Docket No.: 71-9325 (HI-STAR 180 Model)

Subject: Response to Request for Additional Information on HI-STAR 180 Transport Cask
License Amendment Request 9325-1

Response to Request for Additional Information (2nd Round RAIs)

HI-STAR 180 Transportation Package – LAR 9325-1

Figure 4-7.1: Loading-Unloading Characteristics of O-Ring Seals

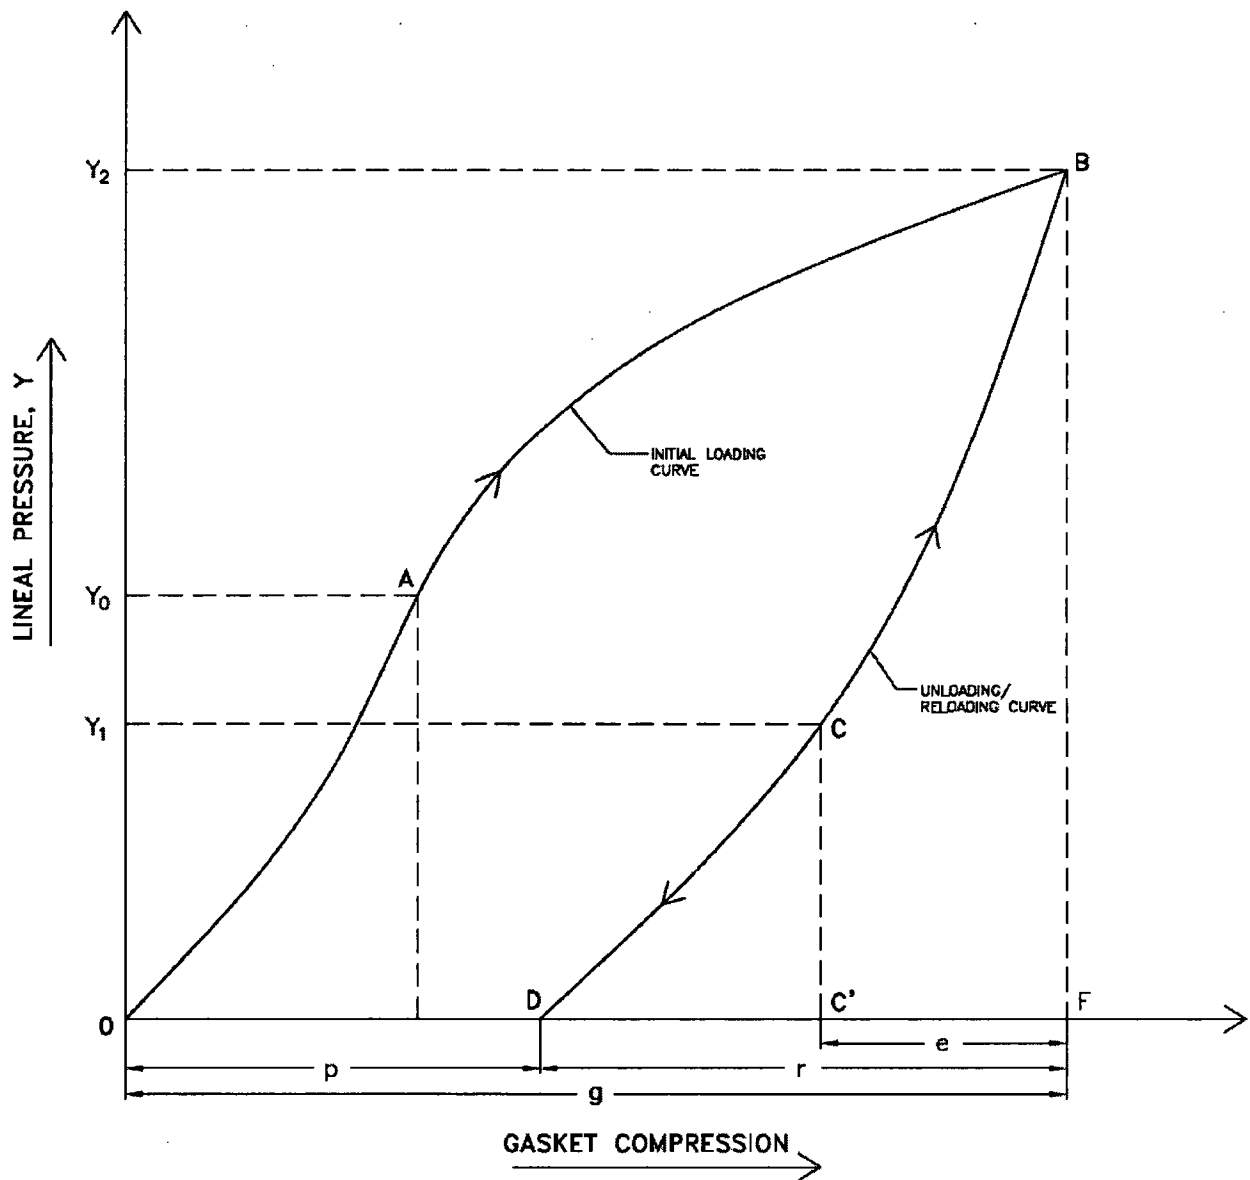
- 4.7 Address the following relative to the "useful" spring-back in association with the seal design and the ability of the closure lid seals to remain leaktight under all hypothetical accident events.

- a. Define the "useful" spring-back to maintain leaktight closure lid seals in the SAR.
- b. Provide justification for the numerical value of 0.01 inches for "useful" spring-back. Address how the spring-back of 0.03 inches that was used in the American Seal & Engineering "Seal option 1" design does not meet the definition of "useful" spring-back.

- c. Provide clear and complete documentation in Section 2.7 of the SAR to show that, based on the structural analysis, the closure lid seals for the American Seal & Engineering "Seal option 1" and the Technetics "Seal option 2" will remain leaktight under all hypothetical accident events based on the "useful" spring-back, as well as the associated margin for these analyses.

- d. Explain how the closure lid seals in the American Seal & Engineering "Seal option 1" and Technetics "Seal option 2" have been designed to provide the minimum "Useful" spring-back required in Table 2.2.12 of the SAR and how this can be concluded from the design drawings provided.

"Useful" spring-back has not been defined in the SAR, although it is a required characteristic in Table 2.2.12 of the SAR. Attachment C.A to HI-2063563 (ML073100307) states, "Based on input from analysis performed by Holtec it was determined that the seal must have the capability of recovering 0.030 inches minimum without the loss of sealing capability during a transient event." This appears to meet the definition of "useful" spring-back provided in the Holtec RAI 4-4 response, therefore it appears the "useful" spring-back should be 0.030 inches. Yet in this amendment request, the wording was changed from "Spring Back at Complete Decompression" to "Minimum Useful Spring Back to maintain leaktightness" and the numerical value was changed from 0.03 inches to 0.01 inches in Table 2.2.12 of the SAR. A justification for this value, in association with the definition of "useful" spring-back, was not provided.

We agree that a clear distinction between the terms "total spring-back" and "useful spring-back" is necessary to avoid incorrect interpretation of the results. For this purpose, Figure 4-7.1 below illustrates the loading/unloading/re-loading curve for a typical O-ring gasket. The terms noted in the figure's legend are used in the explanation below to facilitate presentation.

- a) The term "useful" springback is defined as the amount that the seal can unload without the leakage rate exceeding the required value. In Figure 4-7.1 below, the "useful" springback is the distance between points F and C', denoted by the letter e in the figure. In the prior submission, the term "Spring Back at Complete Decompression" was used which represents the amount that the seal diameter recovers when completely unloaded, i.e., the total springback. In the figure below, the "Spring Back at Complete Decompression" is the distance between point F and the end point (i.e., zero load point) of the unloading curve, D. This distance is denoted by the letter r in the figure.

- b) The following features of the seal's loading unloading curve are germane to understanding the performance of the bolted joints in HI-STAR 180:
 - (i) At initial compression, upon reaching point A (lineal pressure Y0), the gasket can seal the joint to the required leakage rate level. However, additional compression is necessary to insure protection against unacceptable leakage.

- (ii) The point B in the figure represents the optimum compression of the seal to insure maximum joint sealworthiness. The depth of the groove in which the gasket sits is accordingly desired to be smaller than the gasket diameter by the amount denoted by letter g. As explained in the Holtec Position Paper DS-337 (previously submitted as Enclosure 6 to Holtec letter 1553036-NRC), in the controlled compression joint utilized in HI-STAR 180, any bolt load in excess of compressing the gasket by distance denoted by letter g is taken up by the "land". This compression force serves as the initial buffer (reserve) that protects the seal from decompression under loads trying to pry the joint apart.

- (iii) The gasket follows the unloading/reloading curve in Figure 4-7.1 if it were to decompress and re-compress after initial seating. The gasket responds as an elastic element (no hysteresis) during the unloading/reloading cycle.

- (iv) As the gasket is made to relax during unloading, its lineal pressure, Y, drops. The pressure corresponding to point C is the minimum required pressure to meet the minimum specified leak rate.

- (v) If the gasket were to continue to unload, then the lineal pressure will fall below the threshold pressure Y_1 , and the leak rate may begin to exceed the specified minimum. Nevertheless, the gasket will continue to load/unload along the "elastic" curve under all subsequent cycles.
- (vi) In order to maintain joint seal, it is necessary that the compression of the seal lie between points F and C'; i.e., in the useful recovery range.
- (vii) The total recovery, denoted by letter r , is substantially greater than the elastic (useful) recovery, denoted by letter e .

The structural analyses reported in SAR sections 2.6 and 2.7 conclude that the seal will remain fully seated (at point B in Figure 4-7.1) after all of the analyzed Level A and Level D accidents. In other words, the seal springback at the end of the analyzed accident is zero. Thus none of the elastic springback available in the joint (.01 inch in the selected seal designs) is used or needed. While the American Seal & Engineering "Seal option 1" design has a *total springback of 0.03" ($r = .03$ inch in Figure 4-7.1)*, the evaluation of the seal performance should be based on the *useful springback, denoted by letter e* . SAR sections 2.6 and 2.7 have been revised to provide the necessary clarification.
